PACIFIC GAS AND ELECTRIC COMPANY

PGandE Letter No.: DCL-84-141

Mr. John B. Martin, Regional Administrator
U. S. Nuclear Regulatory Commission, Region V
1450 Maria Lane, Suite 210
Walnut Creek, CA 94596-5368Re: Docket No. 50-275, OL-DPR-76
Diablo Canyon Unit 1
SSER 22, Allegation No. 92/93 -- Pipe Support Tube Steel

ENCLOSURE

Fig. A

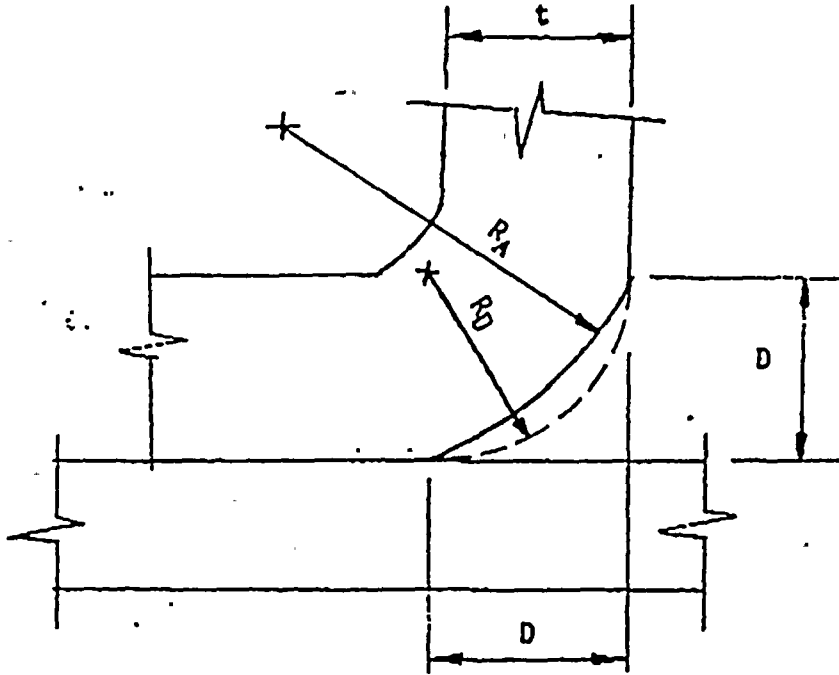
The curved portion of the tube corner is not fabricated to be exactly one quarter of a circle, as indicated by the dotted line in Figure A. Instead, it is actually less than a quarter of a circle as indicated by the solid line in the same figure. Therefore, different radii can be measured for the tube corner dependent upon the measurement method used.

Fig. B Straight Ruler Method
 The implied radius R_D
 is taken as the measured D dimension

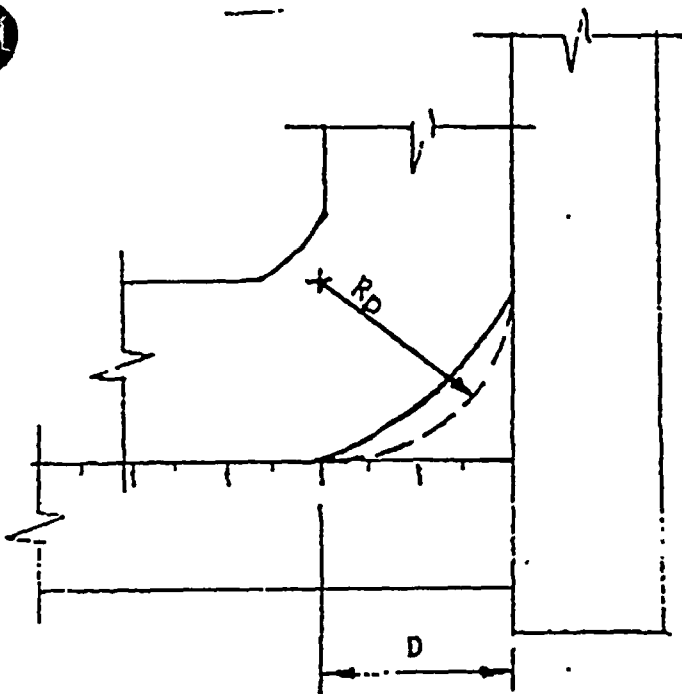
If a straight ruler or mechanic's square is used, as shown in Figure B, a corner dimension, D , is measured. This is considered to be the tangent intersection method. Based on this D dimension, an apparent corner radius of R_D is implied. As shown in Figure B, this may not be the actual radius of curvature. Alternatively, if a concave radius gauge is used, the measured radius is R_A , as shown in Figure C. R_A is the appropriate measurement of the actual curvature. Only when the tube corner is a quarter circle will the two measurement methods yield the same radius. Examples of tubes with the smallest corner dimension, D , were selected by the site piping contractor's QC personnel (Pullman QC) for further measurement. The resulting measurements are summarized in Tables 1A and 1B. The difference between R_D and R_A is clearly shown in these tables. For the $3 \times 3 \times 1/4$ tubes, the apparent radius, R_D , is approximately $1.25 t$ to $1.5 t$ and the R_A is always $2.0 t$ or slightly larger. For the $3 \times 3 \times 1/2$ tubes, R_D is approximately $1.0 t$ and R_A is again $2.0 t$. The NRC staff's contractor used the tangent intersection method of measurement.

The NRC Staff and Pullman QC have reported corner dimensions, as measured by the tangent intersection method, rather than measured by a curvature gauge. As discussed above and as shown in the attached figures, these measurement techniques lead to different conclusions. Although measurement of corner radii had never been an inspection requirement, a few jobsite measurements had confirmed the radius was 2.0 t or greater. The recent measurements made using a curvature gauge and the weld testing that measured the effective throats of the associated flare bevel welds reconfirmed the validity of the 2.0 t or greater radius.
